WISCONSIN ELECTRIC POWER
COMPANY

(Point Beach Nuclear Plant,
Units 1 and 2)

Amendment to License Nos.
DPR-24 and DPR-27
(Increase Spent Fuel
Storage Capacity)

APPLICANT'S ANSWERS TO INTERROGATORIES
PROPOUNDED BY THE STATE OF WISCONSIN
ON OCTOBER 2, 1978

Figure 1

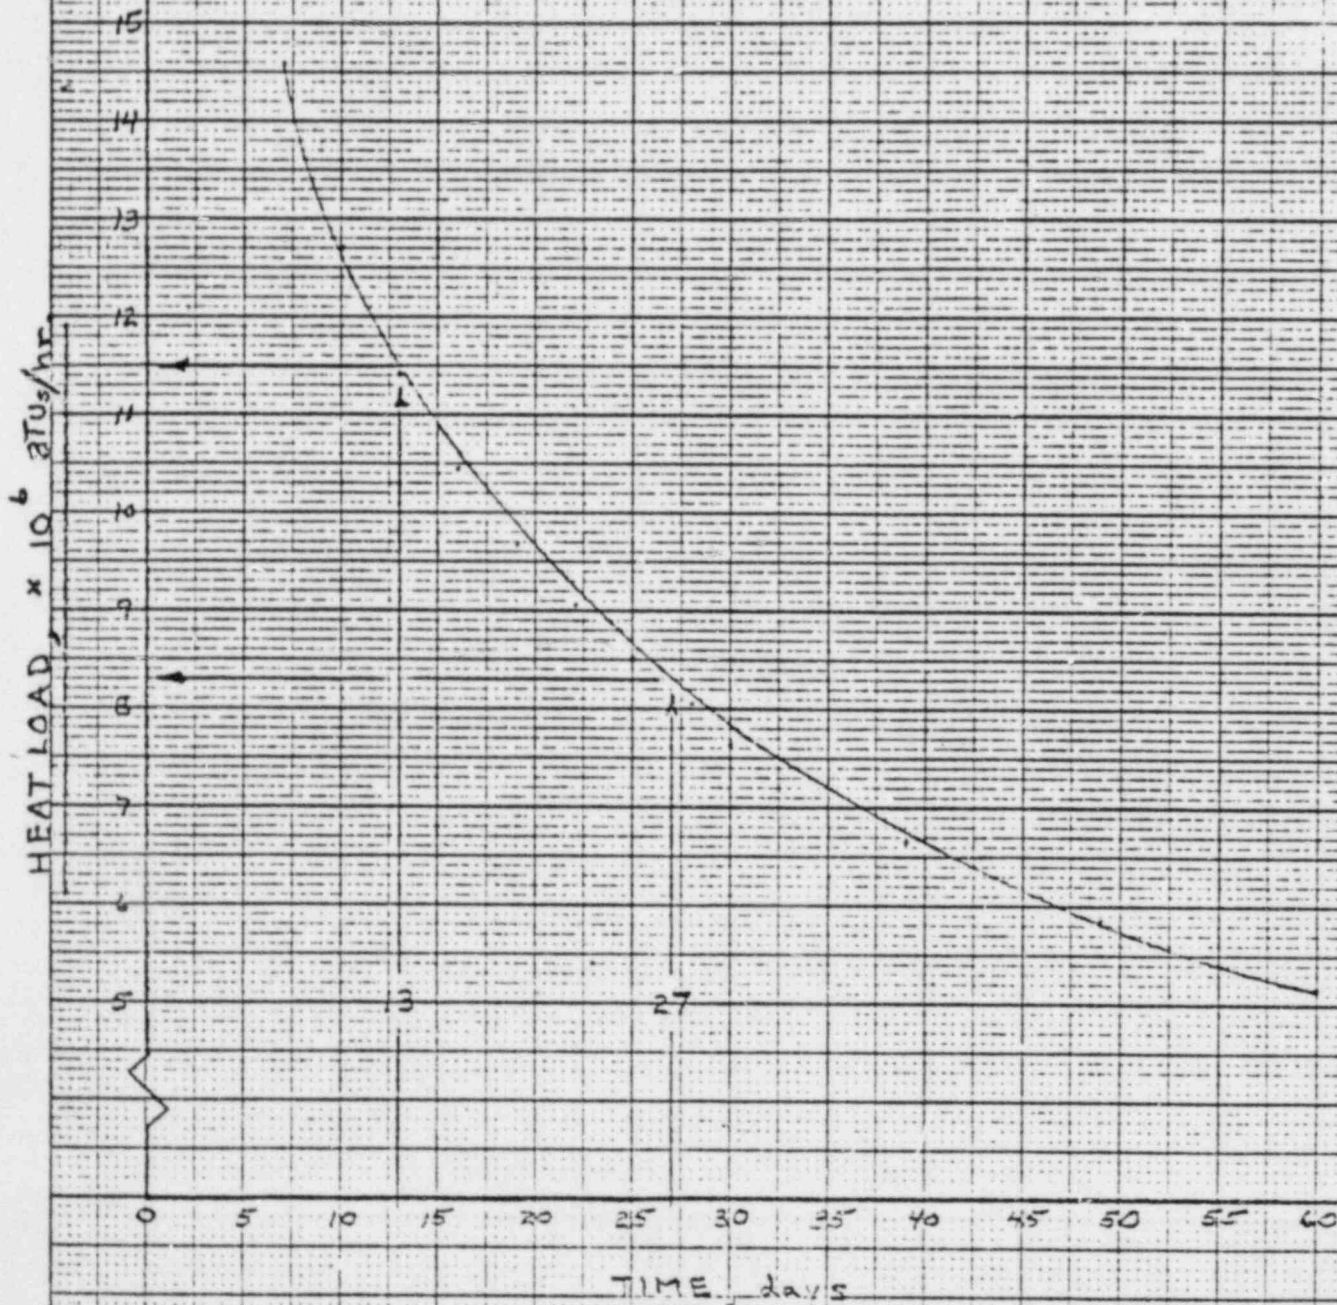
What would be the maximum water temperature reached within the spent fuel pool were cores from both nuclear facilities at Point Beach offloaded into the pool? In calculating this temperature, please assume that the offload of both cores would result in the spent fuel pool being full. Please state the model utilized in calculating this temperature, as well as any assumptions relied upon. How would an increase in the water temperature in the spent fuel pool affect the quantity and quality of radioactive emissions from the pool? Were a temperature increase in the pool to result in boiling and a loss of coolant, how would the quality and quantity of radioactive emissions from the pool be affected? Please state the model utilized and assumptions relied upon in making this determination. What would be the radiation dose received by a person standing next to the spent fuel pool during such a rise in temperature?

The heat load that would be in the spent fuel pool is established as follows, assuming that 13 days are required to unload a core and that the cores are unloaded sequentially with one day pause between unloadings:

a.	decay heat from the second core unload 13 days after shutdown of reactor (from Figure 1)	11.5x10 ⁶ BTUs/hr
b.	remaining decay heat from the first core unload 27 days after shutdown of reactor (13 days for unloading the first reactor, 1 day pause, 13 days for unloading second reactor; from Figure 1)	8.3x10 ⁶ BTUs/hr
c.	residual decay heat from 1260 in-storage assemblies (use 1280 assembly line from Table 4-1 of Attachment A to this Application - no further decay accounted for)	9.38x10 ⁶ BTUs/hr
		<hr/>
	Total decay heat load in pool	29.18x10 ⁶ BTUs/hr

Normally, only one of the two cooling trains is used to maintain the temperature of the pool water at 120°F or less. Using both trains, the cooling system has a design capability to maintain the pool temperature at 120°F with a heat load of 28.2x10⁶ BTUs/hr. The above calculated number exceeds the design capability of the cooling system by 0.98x10⁶ BTUs/hr, or less than 3.5%. However, there is over 5% more heat transfer surface area in each heat exchanger (per the heat exchanger technical manual data sheet) than is used to calculate the design capability. Thus, the cooling system could accommodate the above postulated heat load and still maintain the pool temperature around 120°F.

FIGURE 2

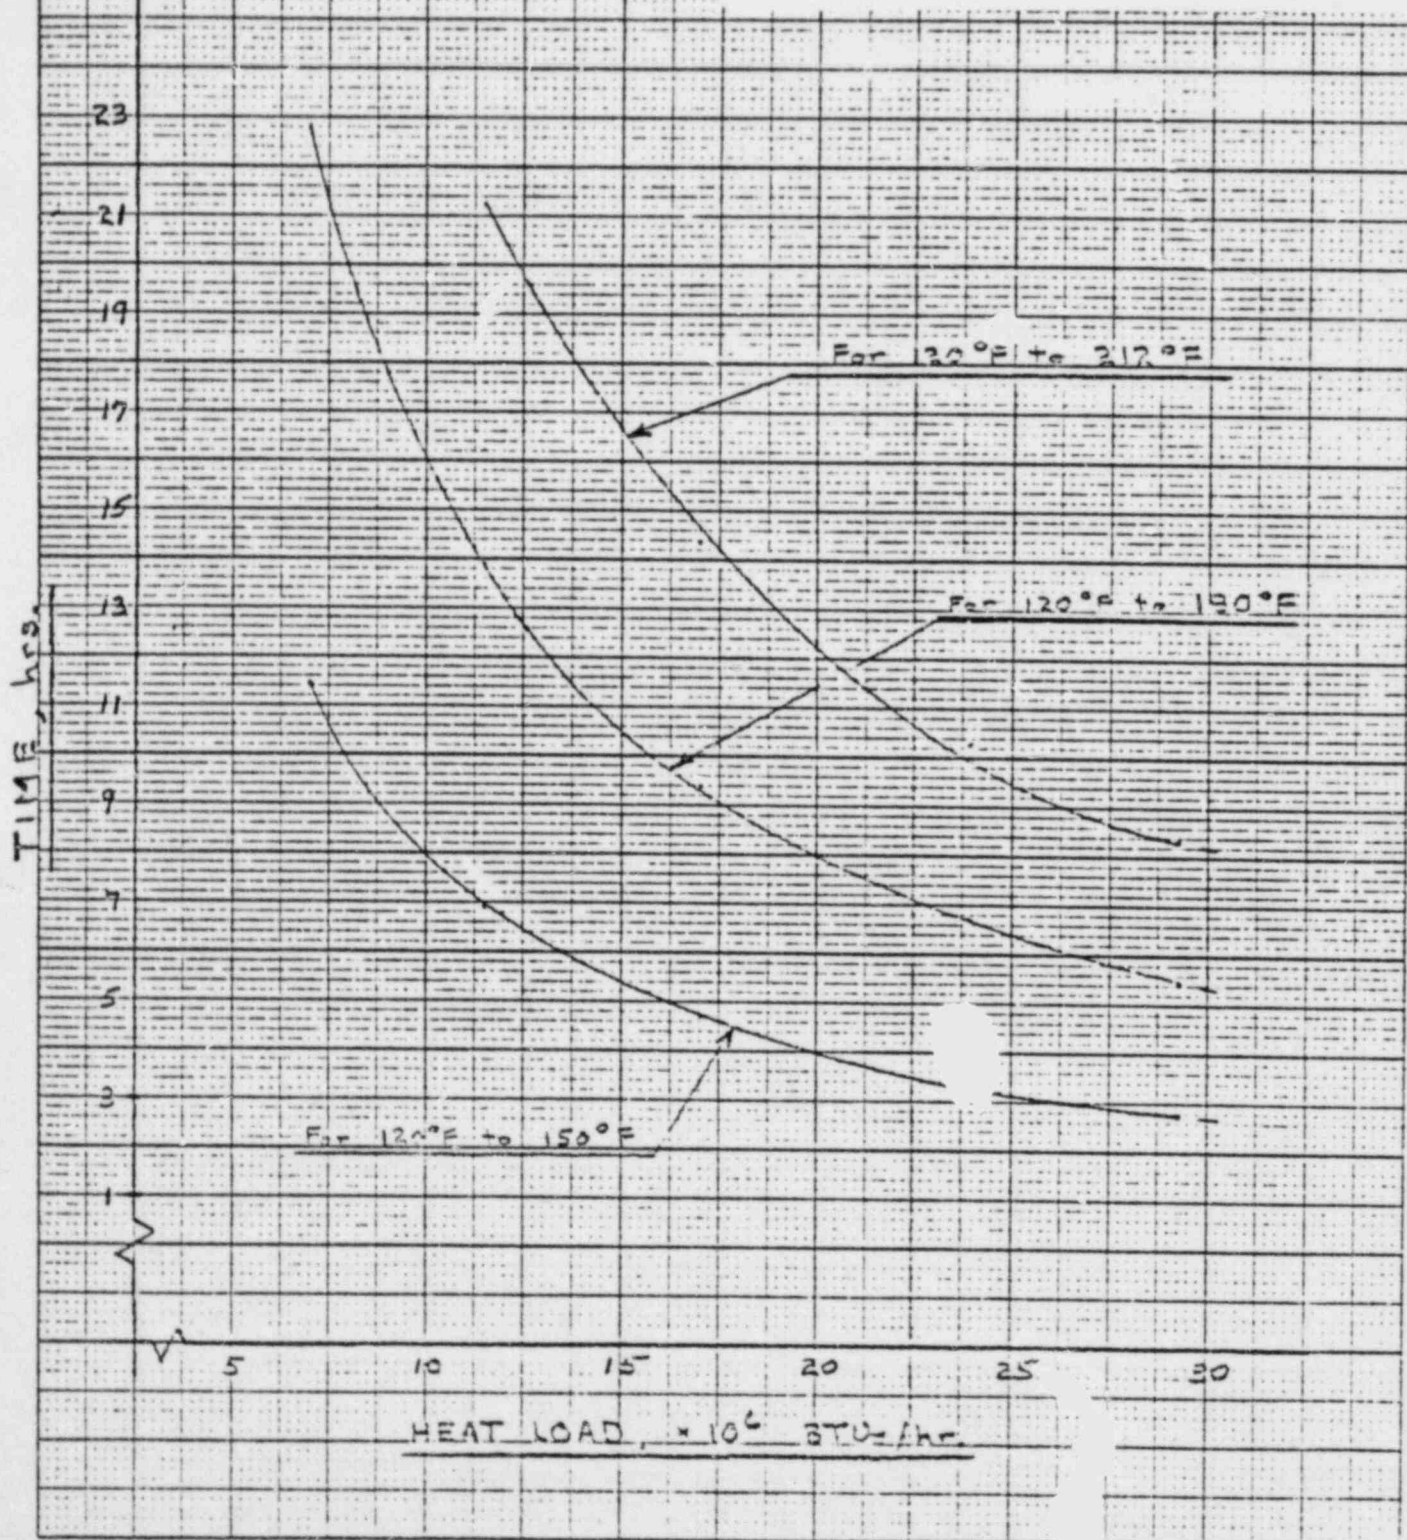
What precautions have you taken to prevent the blockage of the coolant inflow and outflow pipes in the spent fuel pools? What would be the effect on the temperature of the pool of a blockage of either the inflow or outflow pipe? Would such a blockage cause an increase in radioactive emissions from the pool, due either to the inability to filter the pool's water during blockage or due to increased temperatures during blockage? If not, why not? If your answer is yes, please state the expected increase. Also state the model utilized and the assumptions relied upon in making your determination.

piping prior to reaching each pump. If somehow an eight-inch suction pipe was blocked, the cooling could simply be transferred to the other cooling train. If somehow the ten-inch suction pipe was blocked, the cooling system would be shut down until the pipe was cleared. There is a set of bolted flanges in the ten-inch piping (originally installed for pressure testing purposes) and bolted flanges are used to connect the piping to the pumps. These flanges could be disconnected and the lines cleaned out if necessary.

If the cooling system were turned off, the pool water temperature would increase during the time period for cleaning out the blocked line. Figure 2 shows the time required to heat up the spent fuel pool as a function of heat load.

There would be no increase in radioactive emissions from the pool unless the water temperature were to reach the boiling point. Refer to the answer to Interrogatory 5 for the consequences of boiling.

3. Irradiation Testing of 50% B₄C Boraflex

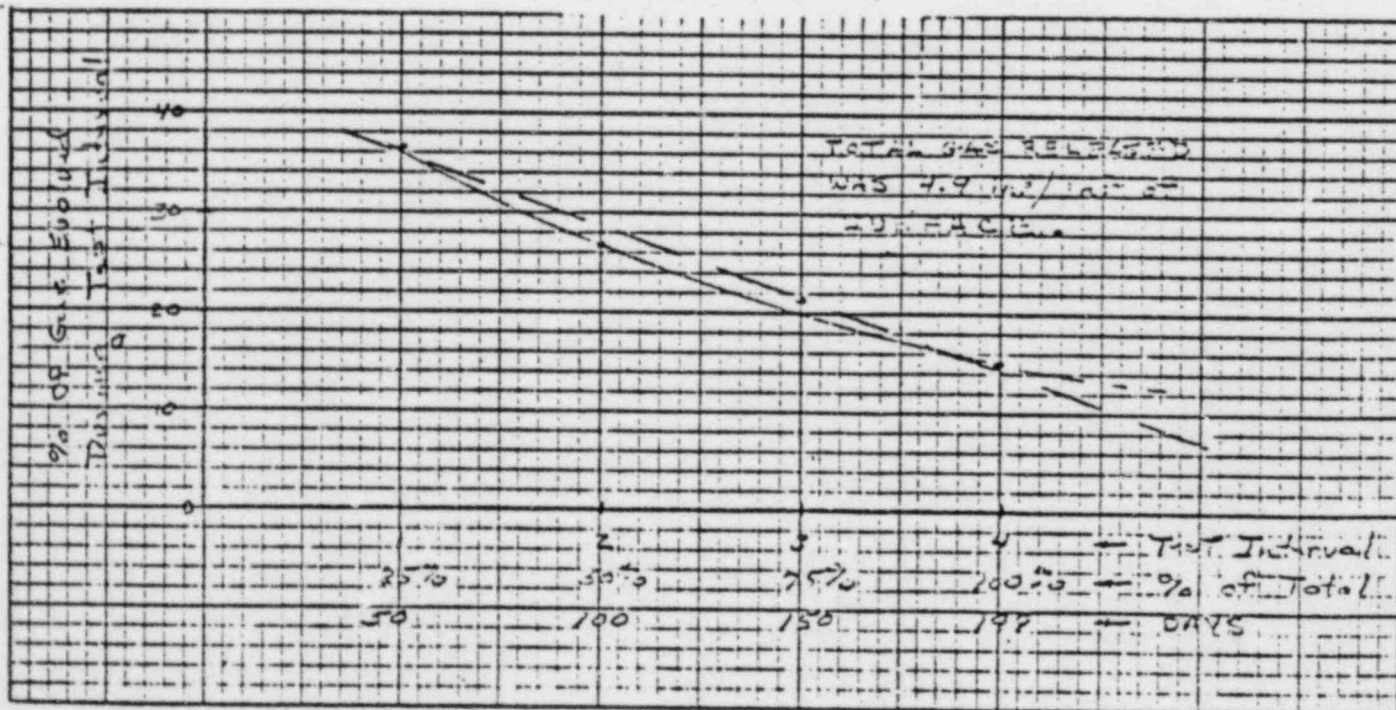
In your response to Question A-12, you cite long-term radiation studies documented in BISCO Report 1047-1. Under what conditions, were these studies conducted; by "conditions", I am referring to the gamma flux to which the boraflex I plates were subjected, the time period in which they were subjected to gamma flux, and the medium (water, air, etc.) in which the experiments took place.

The samples were irradiated and tested at the University of Michigan. The long term irradiation data is presented on page 5.

The irradiation of 8.53×10^{17} N/cm² produced a weight loss of about 6% with a decrease in all of the dimensions.
